ADDENDUM NO. 2

PROJECT NO. DGS C-0946-0012 PHASE 006

PROJECT TITLE - PA State Museum & PHMC Tower - Infrastructure Upgrades and Renovations

Design Resources Group Architects AIA
270 Davidson Ave, Suite 303
Somerset, NJ, 08873

DRAWING NUMBER
AD113

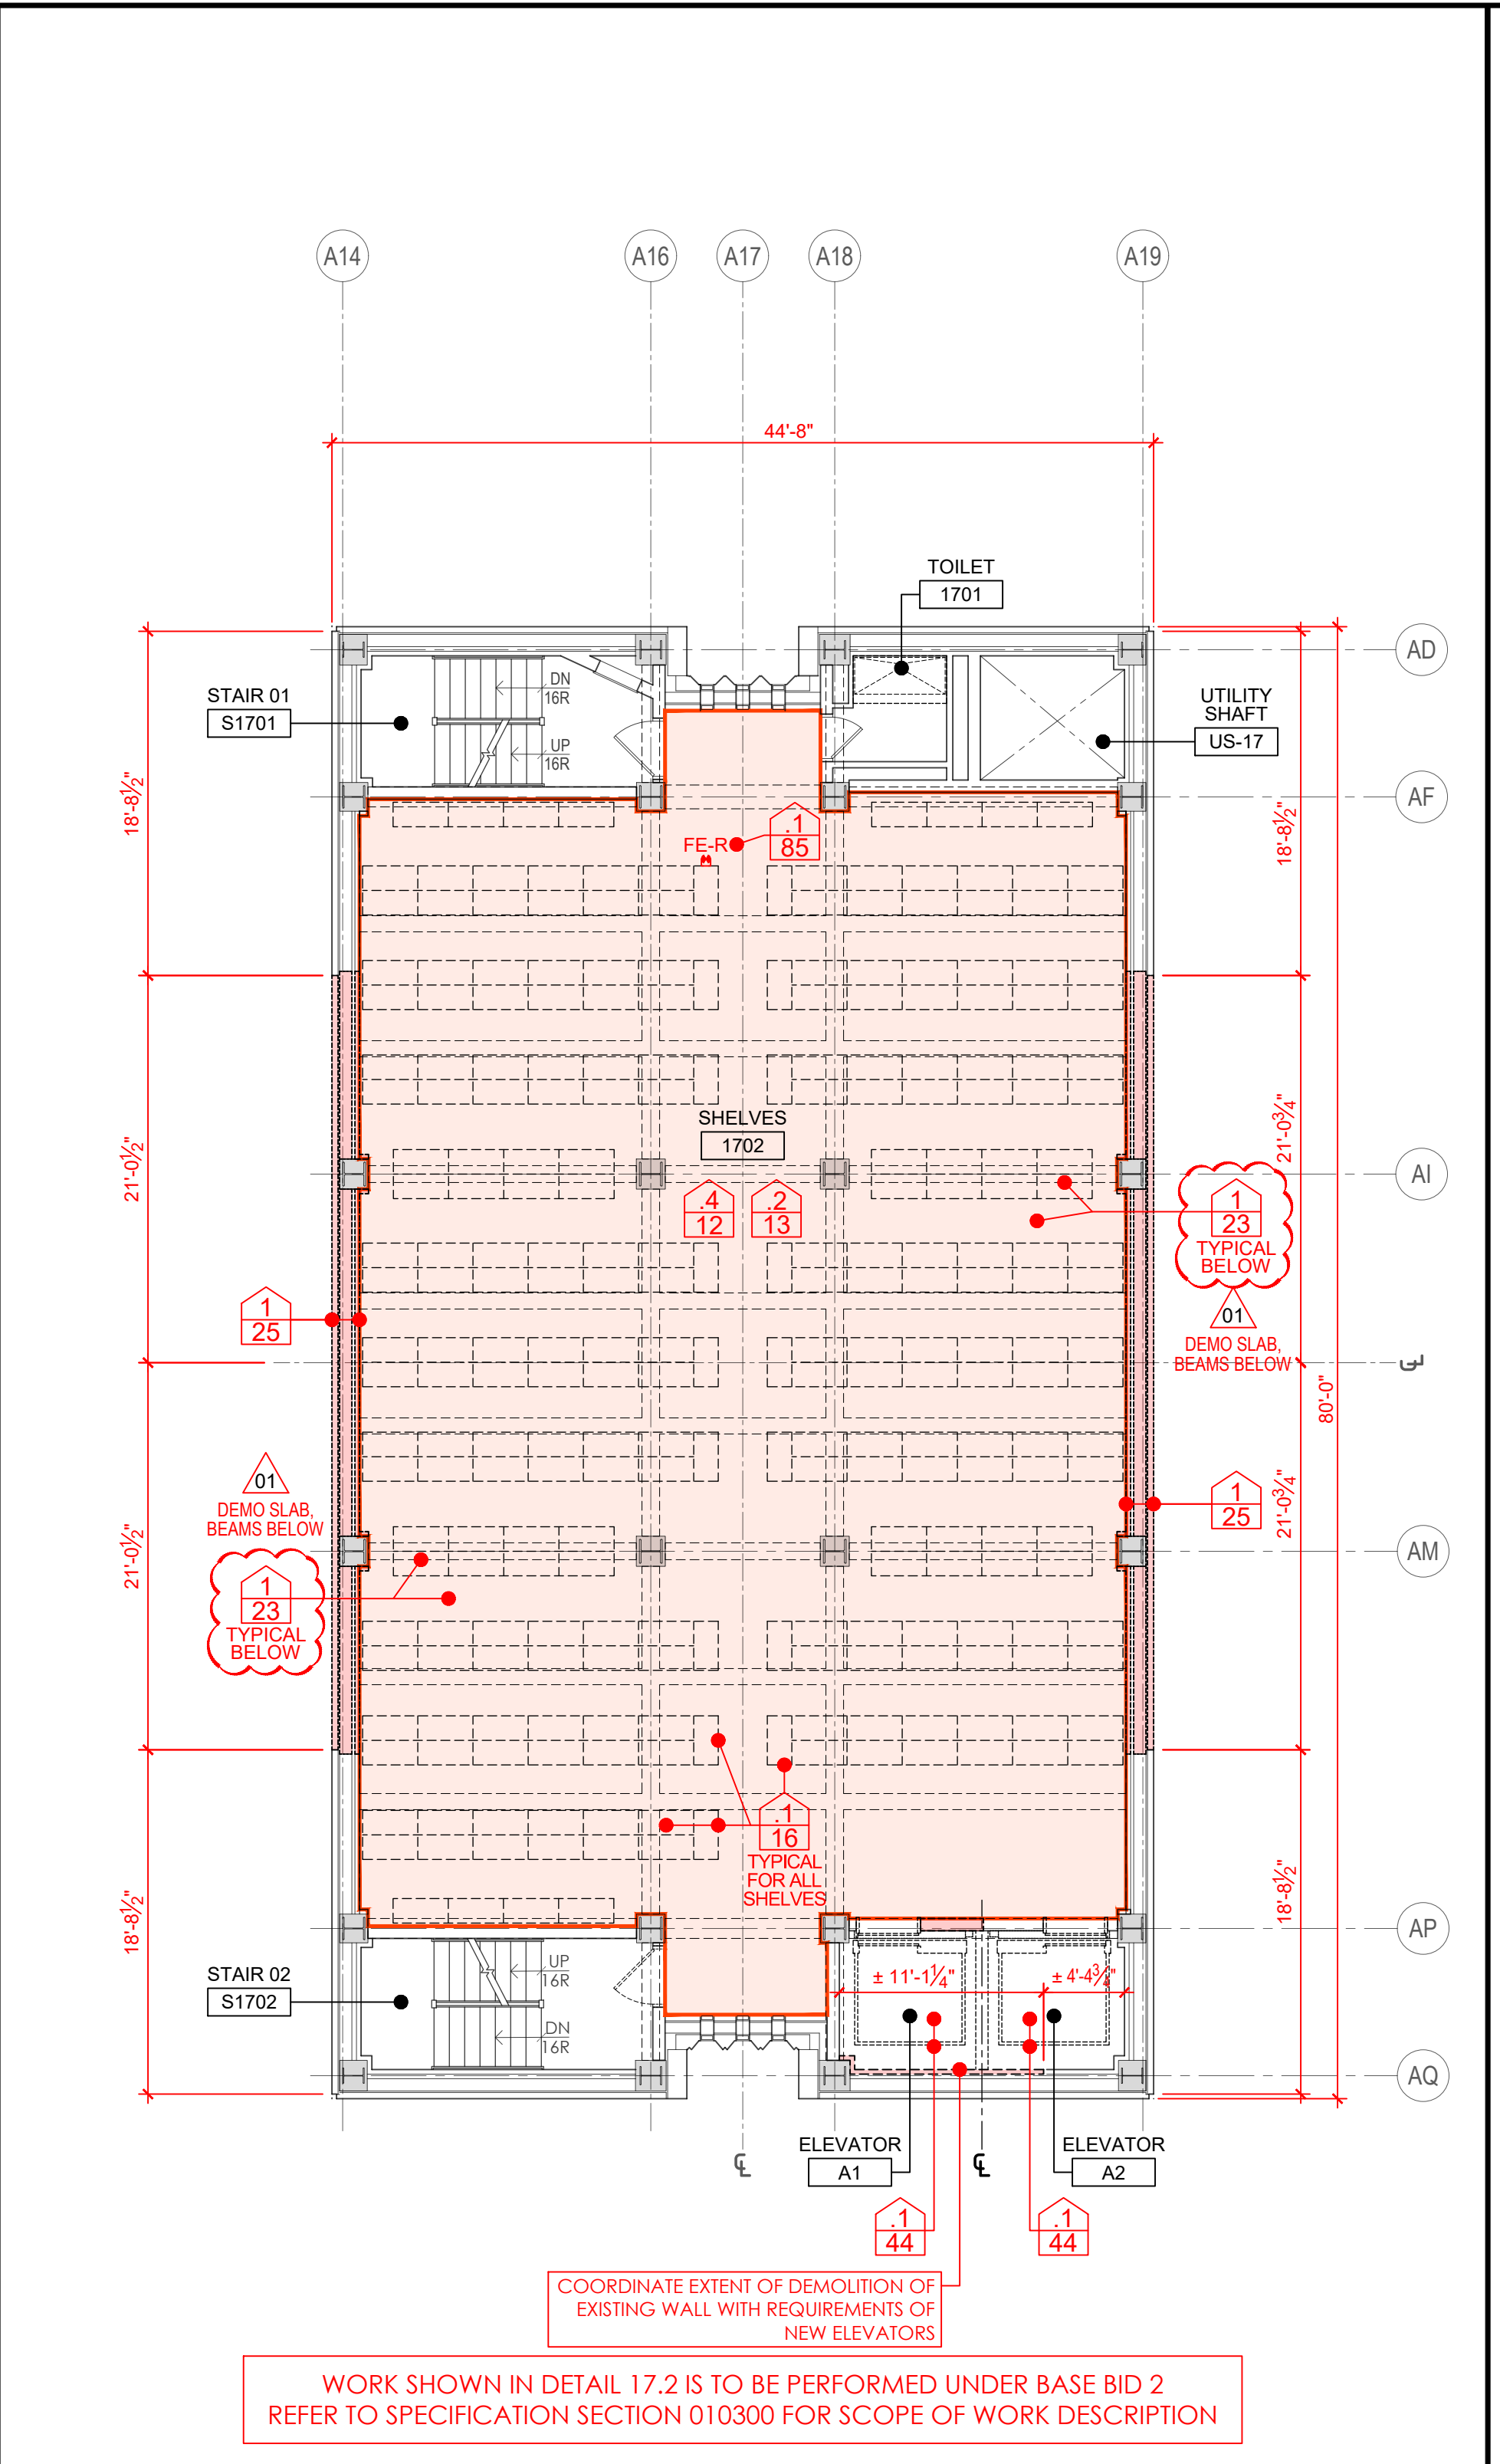
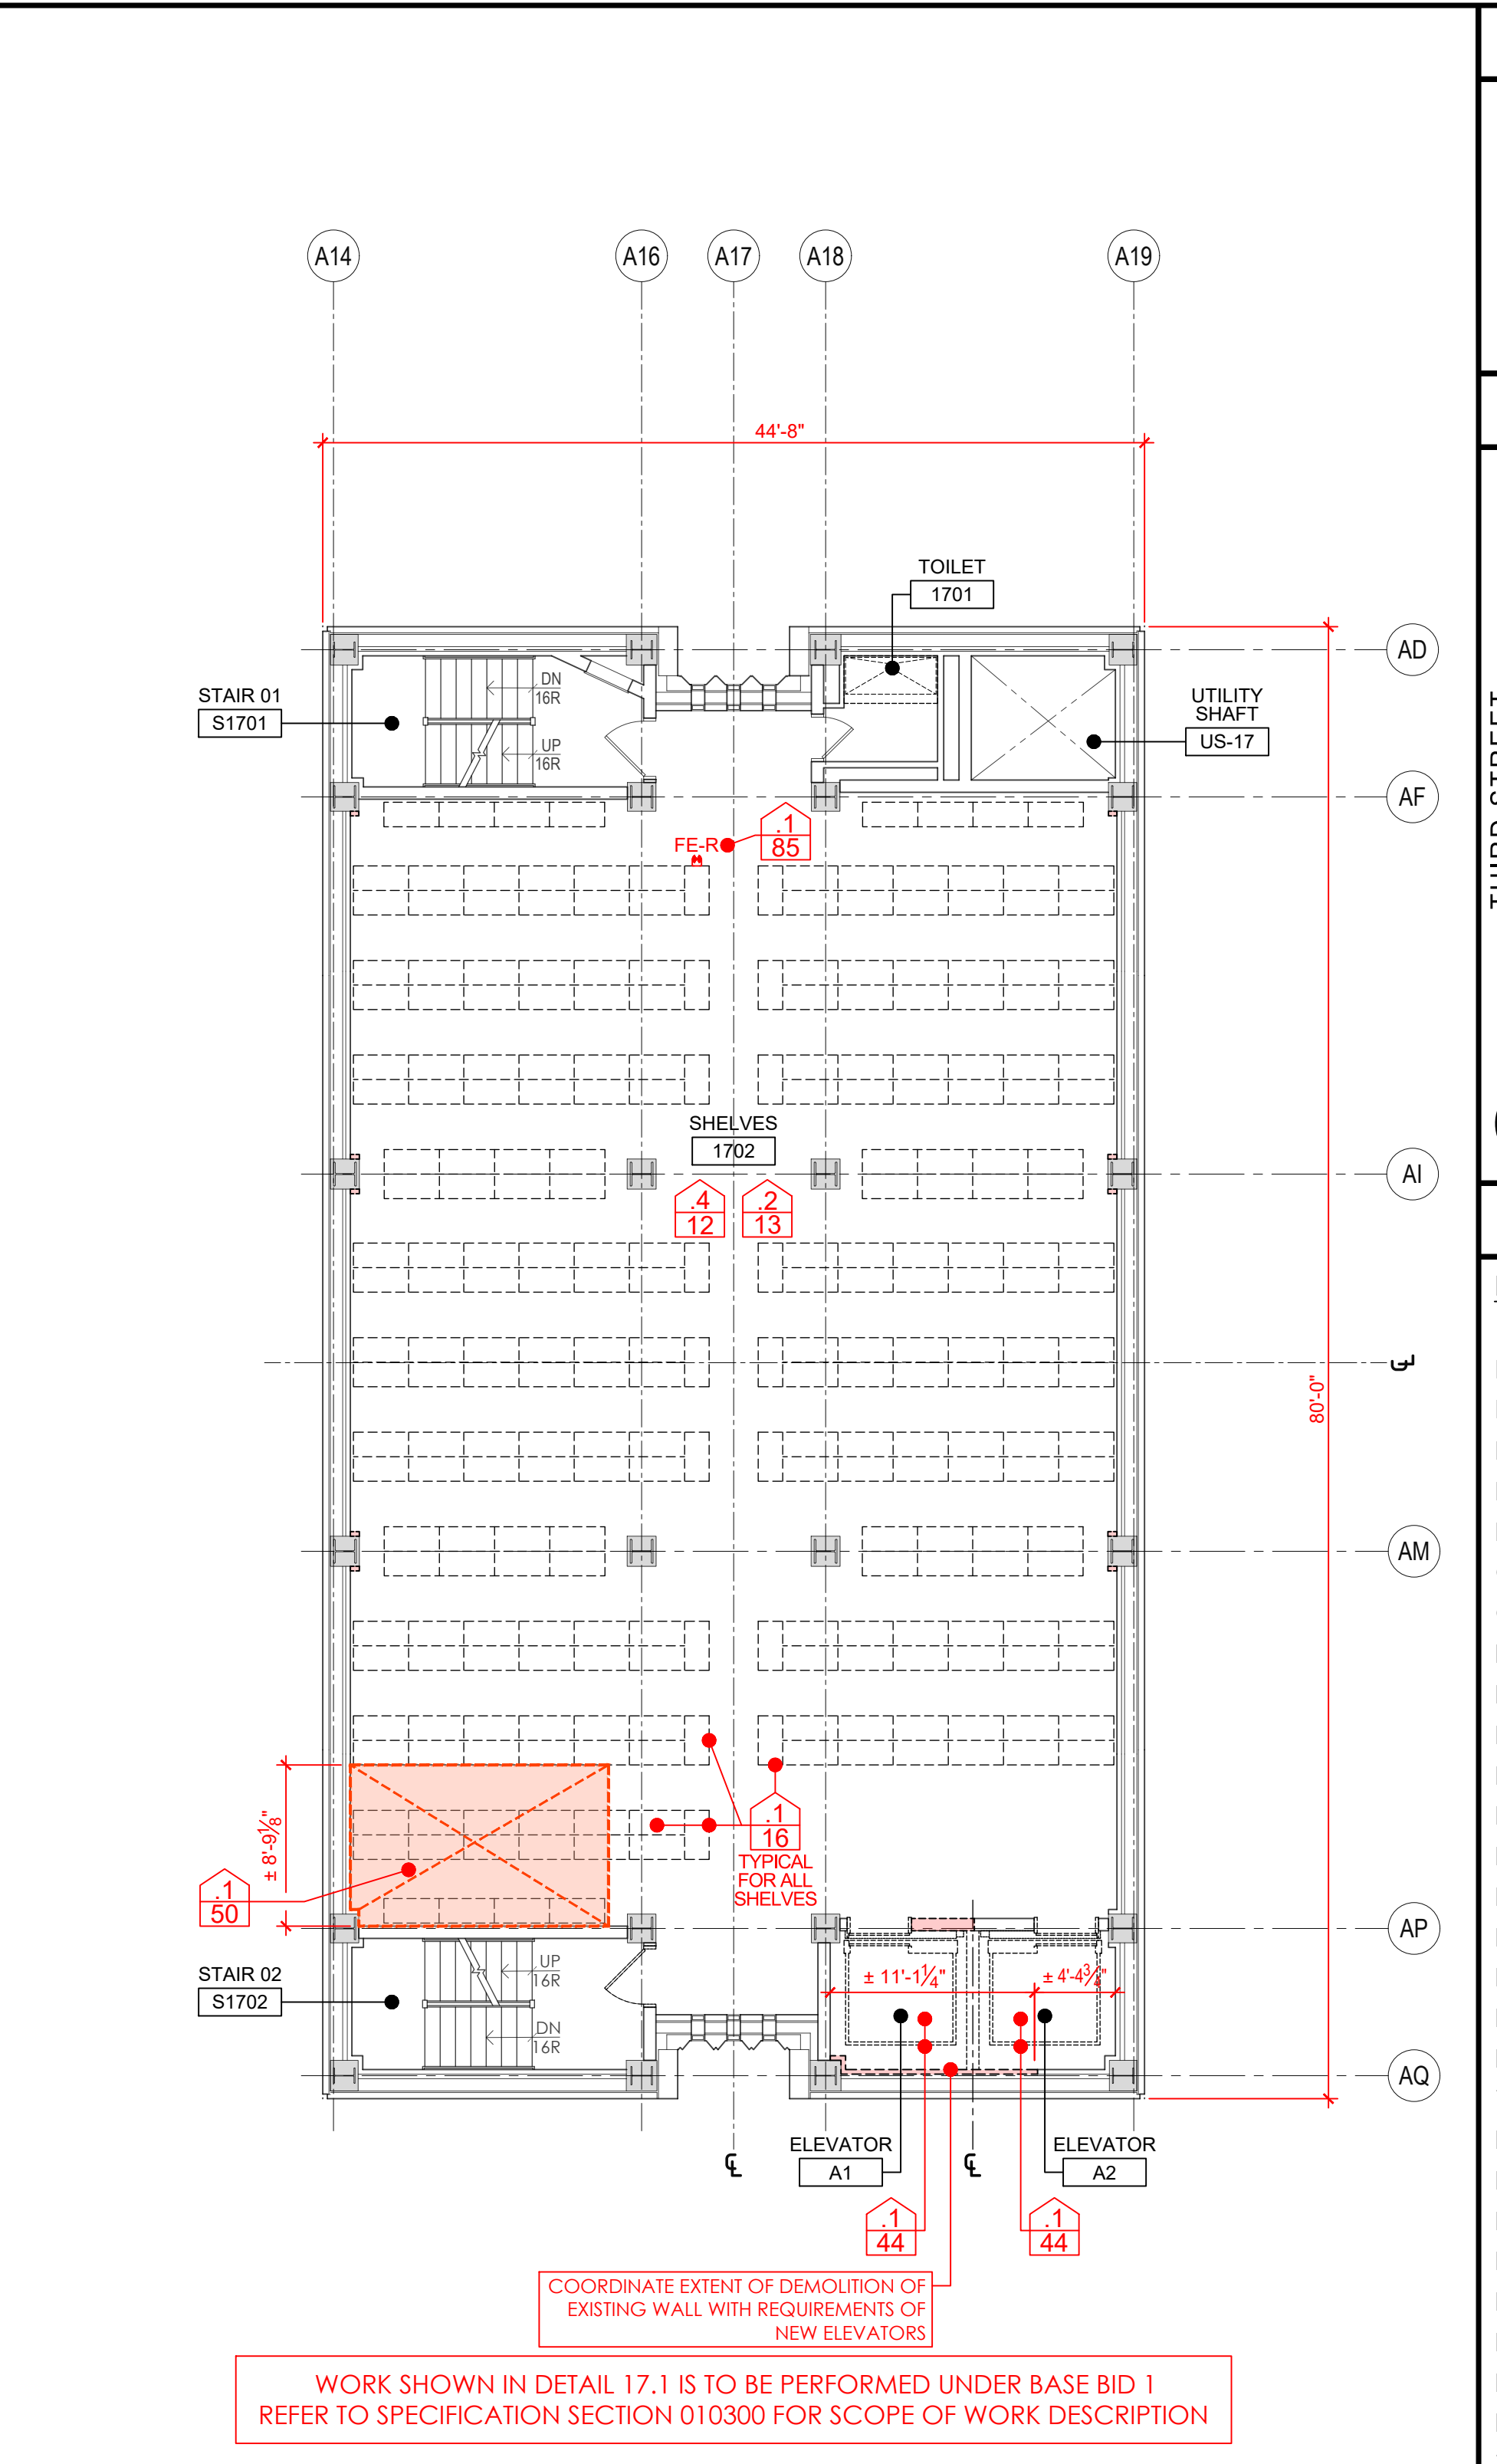
Item 13 - Drawing AD113 - At Plan 17.2, at Demo Note .1/23, deleted note reading "TYPICAL ABOVE" and added note "TYPICAL BELOW."

Item 14 - Drawing AD113 - At Plan 18, at the upper right corner, replaced Demolition Note .1/01 with .1/94.

Item 15 - Drawing AD113 - At Plan 18, at the upper right corner, added Demolition Note .1/91 covering removal of slab inside of shaft at 18th floor level.

Item 16 - Drawing AD113 - At Plan 19, added notes to show the extend of demolition of the west portion of the low roof.

Item 17 - Drawing AD113 - At Plan 20, added Demolition Keynotes.
